Keller Associates, Inc. has reviewed the Preliminary Plat for the Fountain Park Subdivision dated April 28, 2021. We reviewed the applicant's package to check conformance with the City's Subdivision Ordinance and coordinated our review with Shawn L. Nickel. We have the following comments and questions based on our review.

**Project/File:** **Fountain Park Subdivision/ SPP21-0015/ AZ-21-19/ DA-21-24/ PP-21-17**  
*This is an annexation and rezone application to annex 60.21 acres into the City of Star with an R-5 zoning and a preliminary plat application to develop 251 residential lots and 27 common lots on 60.21 acres with a development agreement.*

**Lead Agency:** City of Star

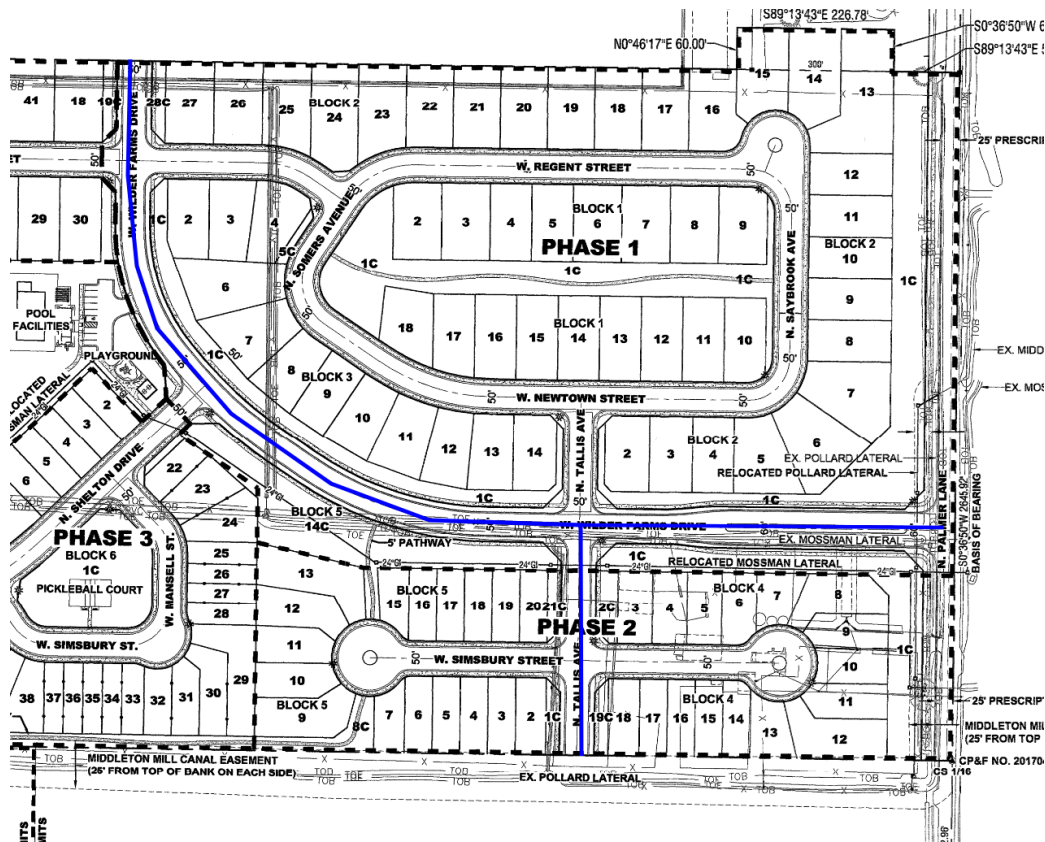
The applicant has proposed to construct the streets as 36-foot wide collector street sections with vertical curb, gutter, 8-foot wide planter strips within 50-feet of right-of-way and 5-foot wide detached concrete sidewalks located outside of the right-of-way. The applicant has proposed to construct the entry portion of Wilder Farms Drive as a 52-foot wide street section with 21-foot wide travel lanes, a 12-foot wide landscape median, vertical curb, gutter, 8-foot wide planter strips within 60-feet of right-of-way and 5-foot wide detached concrete sidewalks located outside of the right-of-way.

d. **Staff Comments/Recommendations:** The applicant's proposal to construct Wilder Farms Drive and Tallis Avenue meets District Policy and should be approved, as proposed. For detached sidewalk located outside of the right-of-way, the applicant should be required to provide a permanent right-of-way easement that extends from the right-of-way line to 2-feet behind the back of sidewalk.

The applicant should be required to plat the landscape median as right-of-way owned by ACHD. The applicant or homeowners association shall enter into a license agreement with ACHD for the maintenance of the landscape median.

8. Construct all collector streets within the site as 36-foot wide collector street sections with vertical curb, gutter, 8-foot wide planter strips within 50-feet of right-of-way and 5-foot wide detached concrete sidewalks located outside of the right-of-way, as proposed.

9. Construct the entry portion of Wilder Farms Drive as a 52-foot wide street section with 21-foot wide travel lanes, a 12-foot wide landscape median, vertical curb, gutter, 8-foot wide planter strips within 60-feet of right-of-way and 5-foot wide detached concrete sidewalks located outside of the right-of-way.

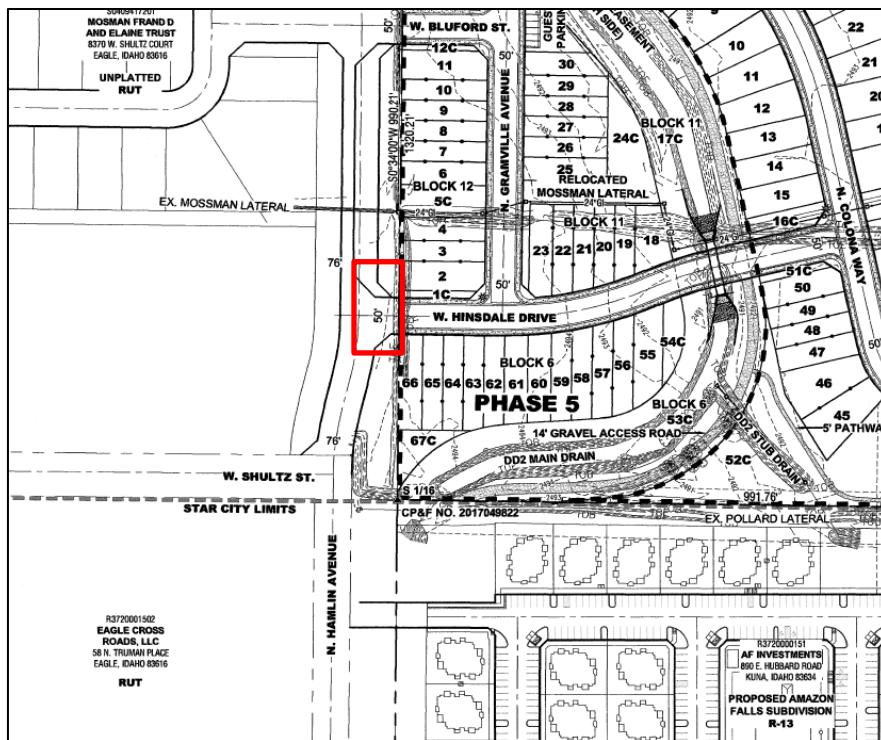
The applicant has proposed to construct a cul-de-sac off-site at the terminus of Colona Way, a local road that stubs to the site’s north property line, shown below.

The applicant has proposed to construct a small portion of Hinsdale Drive to intersect with Hamlin Avenue off-site and dedicate 50-feet of right-of-way for this small off-site segment shown below, but has not proposed a street section for this segment. They have indicated they are currently working with that property owner to obtain right-of-way or a permanent right-of-way easement to construct Hamlin Avenue and Hinsdale Avenue.

**Staff Comments/Recommendations:** The applicant's proposal for the internal local road street sections, cul de sacs and knuckles meets District Policy and should be approved, as proposed. The applicant shall plat the landscape islands as right-of-way owned by ACHD. The applicant or homeowners association shall enter into a license agreement with ACHD for the maintenance of the landscape islands.

In order to construct Hinsdale Drive to intersect Hamlin Avenue off-site as proposed, the applicant should be required to obtain approval from the property owner directly west of the site, and provide the legal description and exhibit for the right-of-way dedication to ACHD for the off-site segments prior to ACHD's approval of the construction plans that include the construction of Hinsdale Drive to the site's west property line. At a minimum, the applicant should be required to construct the off-site segment of Hinsdale Drive with a minimum of 24-feet of pavement with 3-foot wide gravel shoulders within a minimum of 50-feet of right-of-way. Hinsdale Drive will be required to be fully improved as a full 36-foot wide local street section with curb, gutter and sidewalk within 50-feet of right-of-way when that parcel develops in the future. The applicant may construct this road as a 36-foot wide local street section with curb, gutter and 5-foot wide concrete sidewalk within 50-feet of right-of-way if desired. If street trees are desired, an 8-foot wide planter strip is required. For detached sidewalk located outside of the right-of-way, the applicant may reduce the right-of-way width to 2-feet behind the back of sidewalk and provide a permanent right-of-way easement that extends from the right-of-way line to 2-feet behind the back of sidewalk.

In order to construct the temporary cul-de-sac at the terminus of Colona Way that is proposed off-site on the parcel directly north of the site, the applicant should be required to obtain approval and provide a temporary easement for the cul-de-sac from that property owner prior to ACHD's approval of the construction plans for the phase of the development that will construct Colona Way to stub to the site's north property line. If the applicant cannot obtain approval and a temporary cul-de-sac easement from the parcel owner to construct the cul-de-sac prior to ACHD's approval of the construction plans for the phase of the development that includes Colona Way, then the applicant should be required to construct a temporary cul-de-sac within the site at the terminus of Colona Way at the site's north property line. The cul-de-sac shall be

13. Obtain approval from the property owner directly west of the site to construct the off-site roads Hamlin Avenue and Hinsdale Avenue, and provide the legal description and exhibit for the right-of-way dedication to ACHD prior to ACHD's approval of the construction plans that include the construction of Hinsdale Drive to the site's west property line.

27. Install a sign at the terminus of Colona Way and Bluford Street stating that "THIS ROAD WILL BE EXTENDED IN THE FUTURE".
28. Construct a temporary cul-de-sac at the terminus of Colona Way, as proposed. If the temporary cul-de-sac will be located off-site on the parcel directly north of the site, as proposed, obtain approval and provide a temporary easement for the cul-de-sac from that property owner prior to ACHD's approval of the construction plans for the phase of the development that will construct Colona Way to stub to the site's north property line.
